# Consent documentation quality for new housing

## BRANZ Study Report SR355

### Abstract

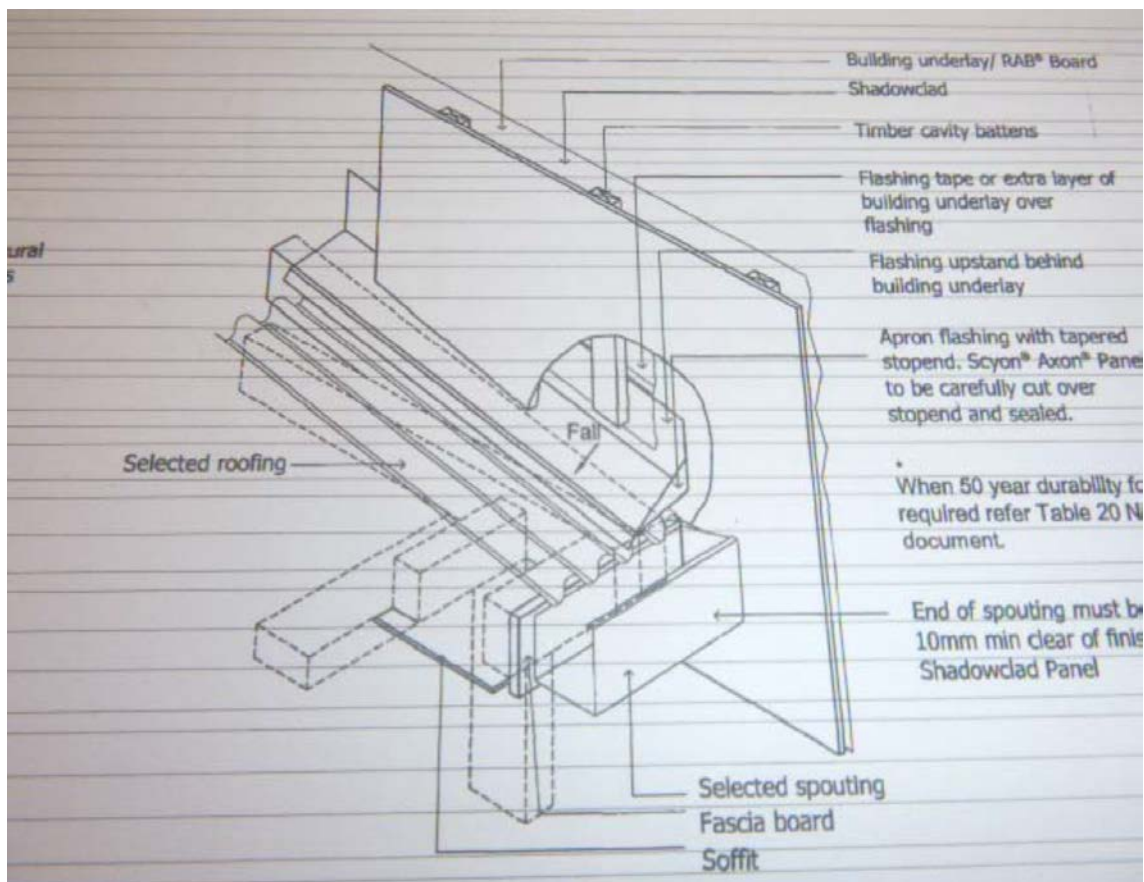
**Details are referenced but are missing or are not applicable.**

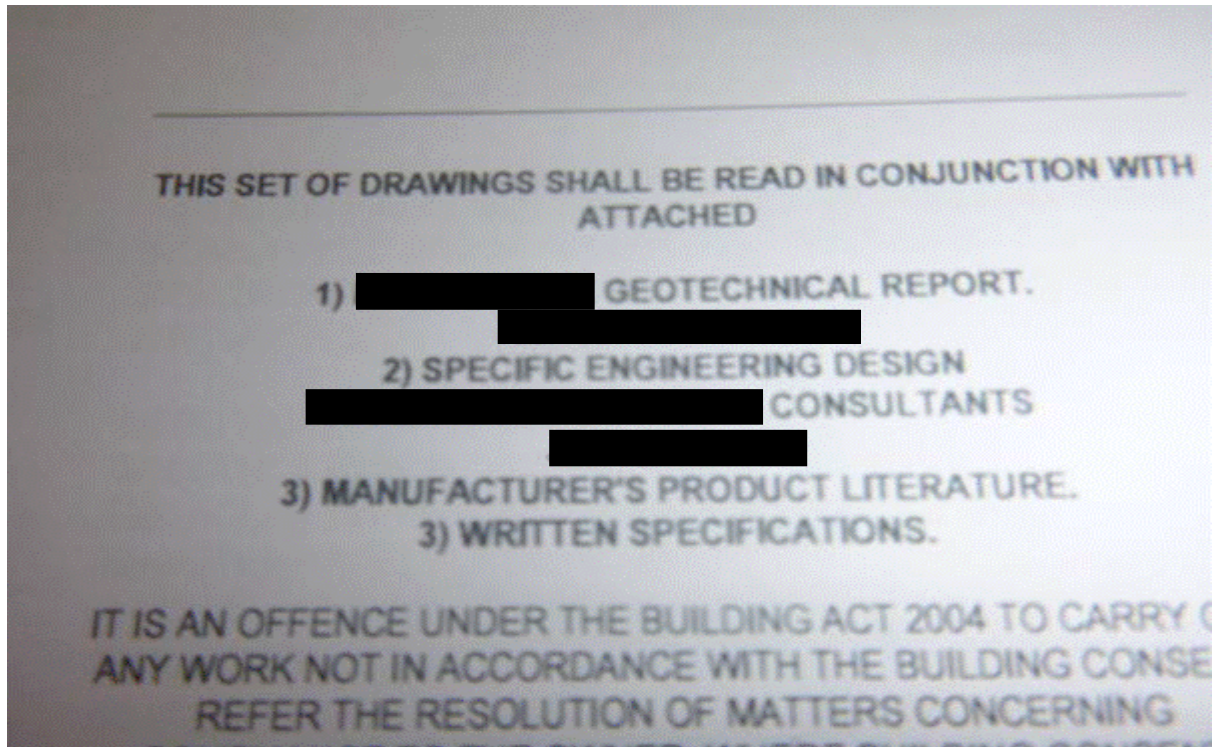
**Helpful 3D detail, but clarity is adversely affected by the horizontal lines.**

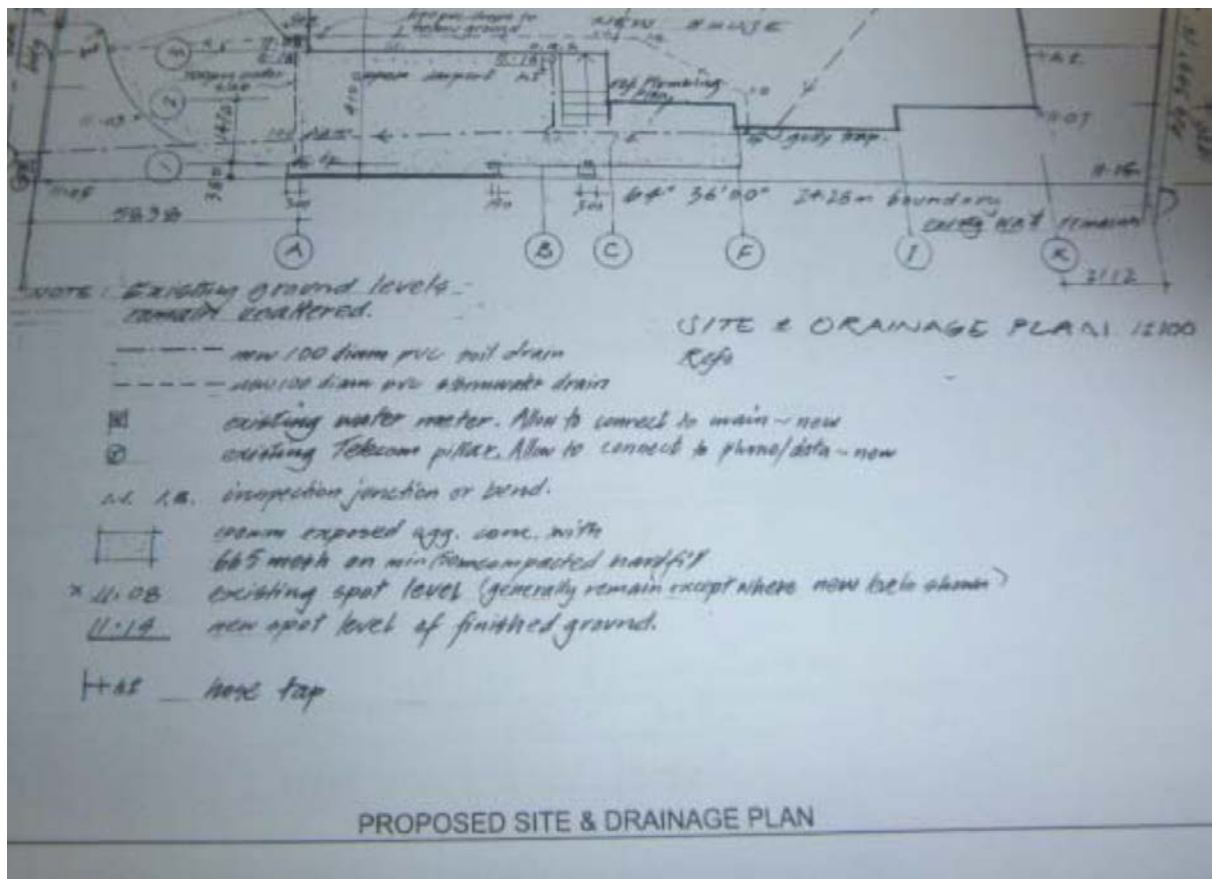
Not all of these references are helpful to the builder: What part of the geotechnical report does the builder need to read? What manufacturer's product literature applies?

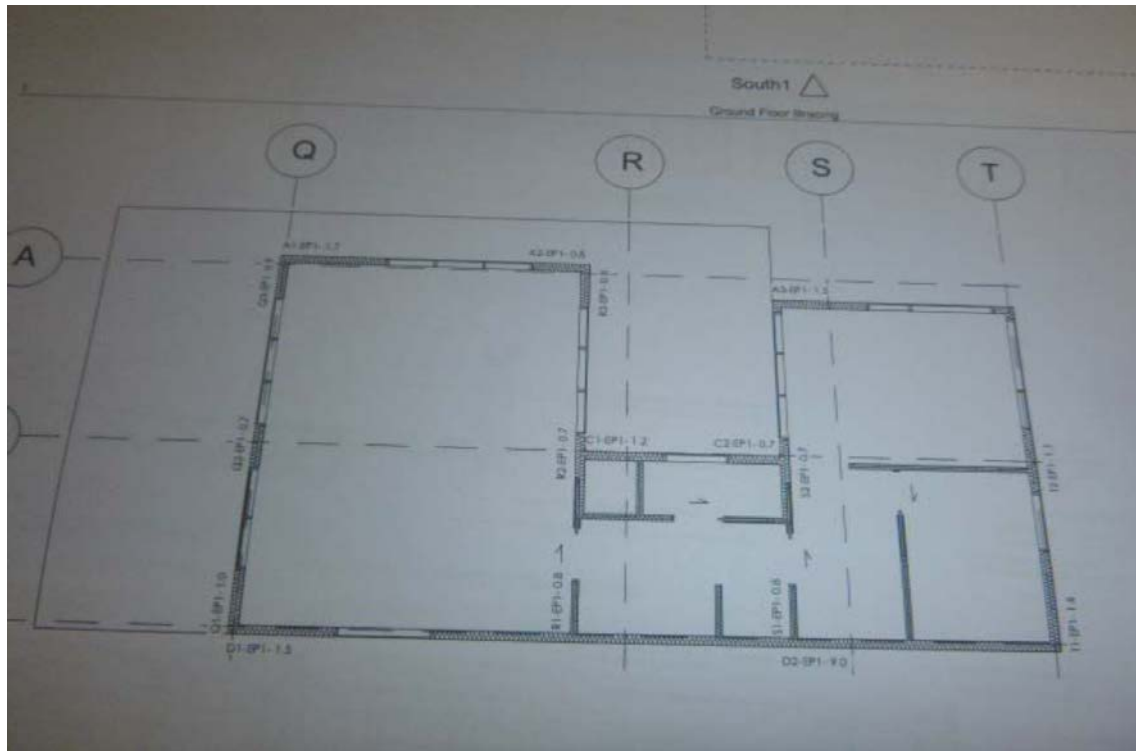
Handwritten notes can be difficult to read.

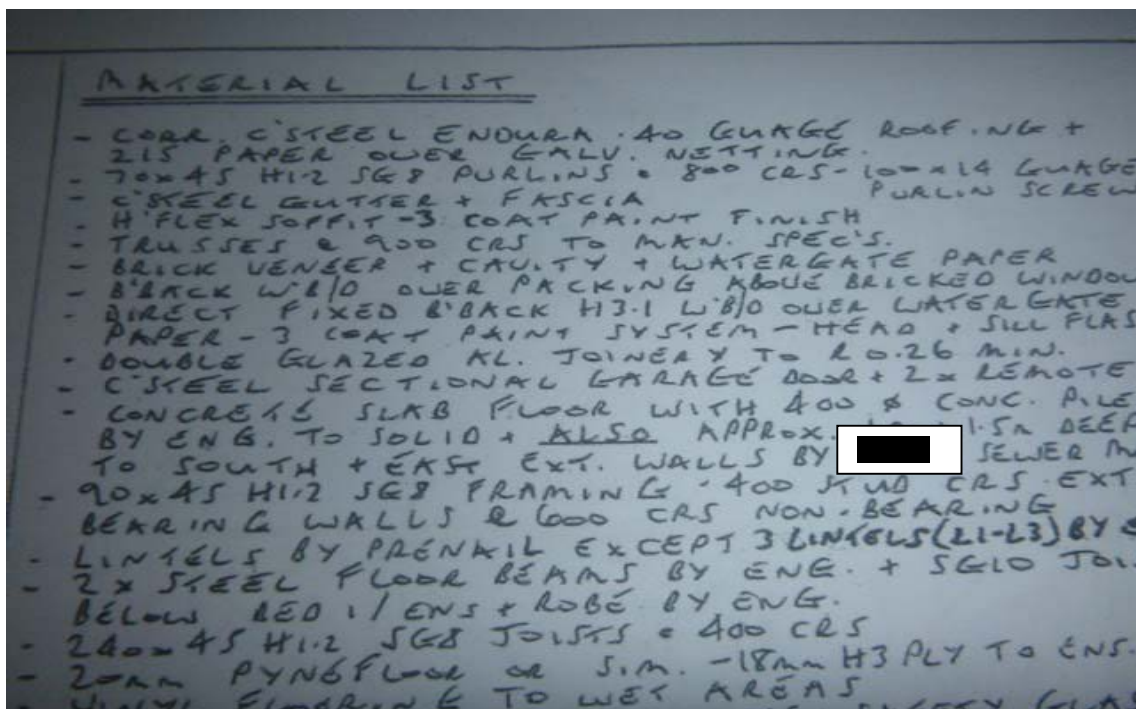
Bracing plan has no key to the bracing type.

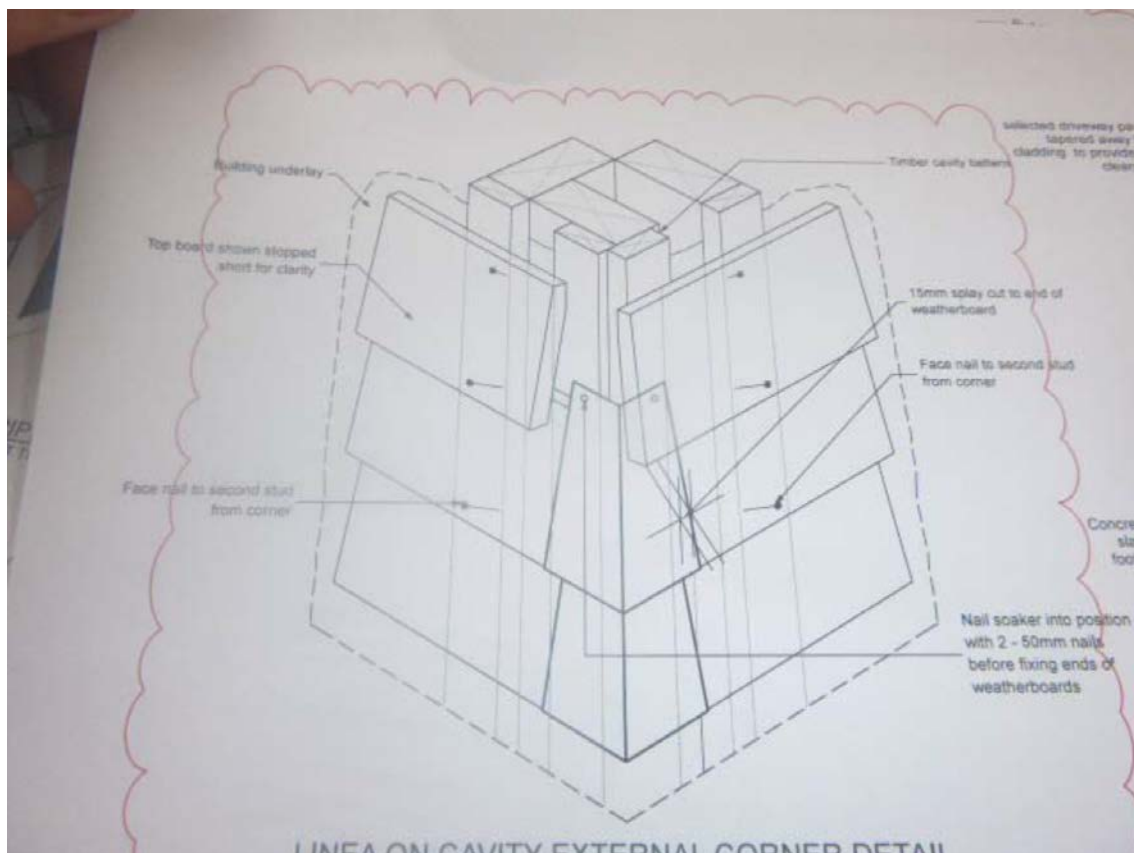
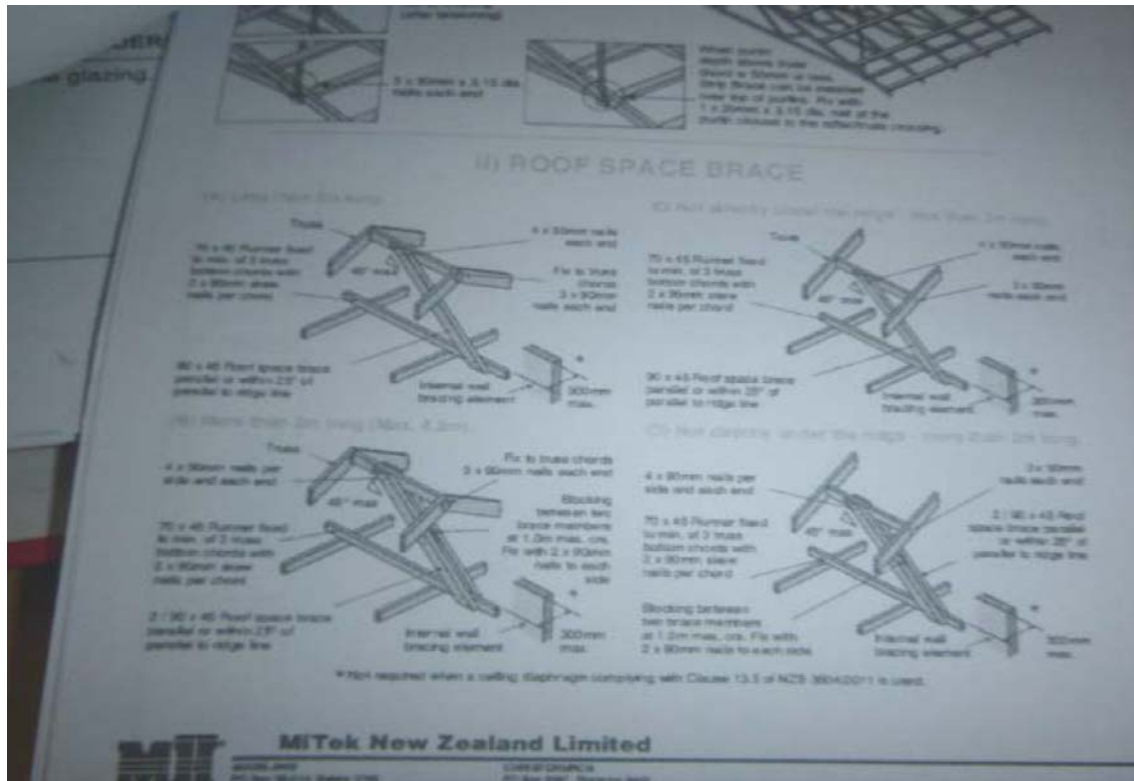
A materials list is good to have but can be difficult to read.

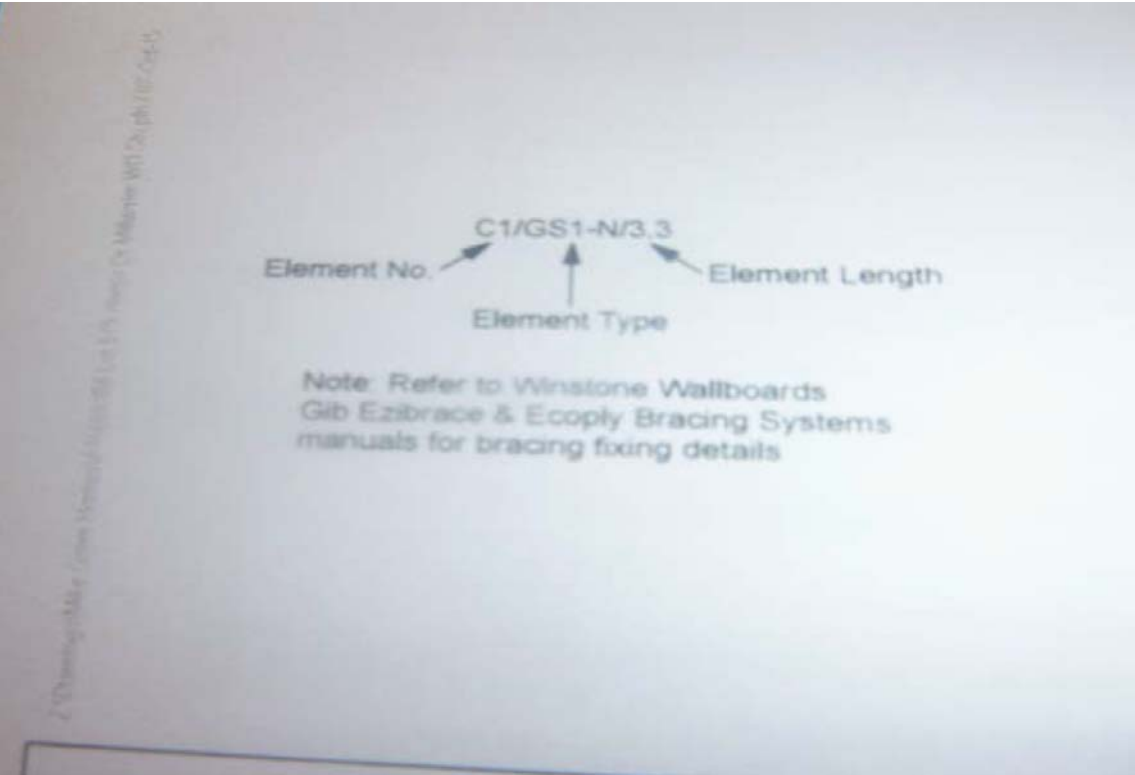
Typical examples of use of manufacturers' details – not all details are relevant for this house.

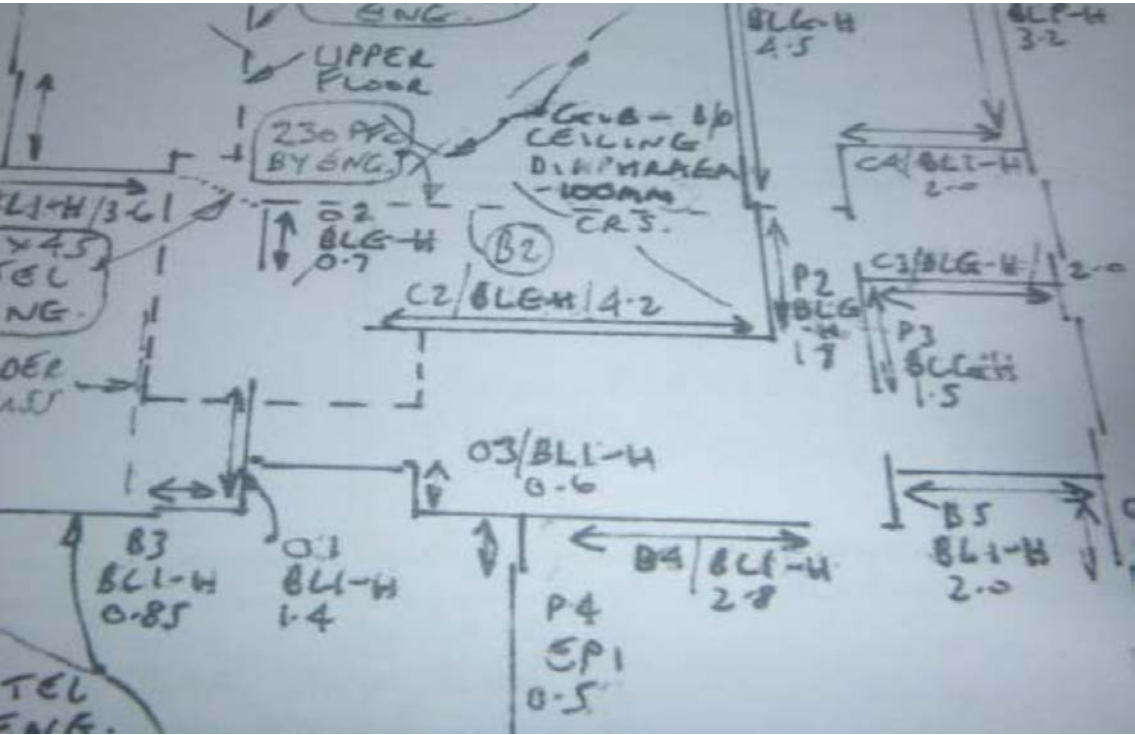
Typical example of reference to manufacturer’s literature for construction details.

Bracing plan is very difficult to read.
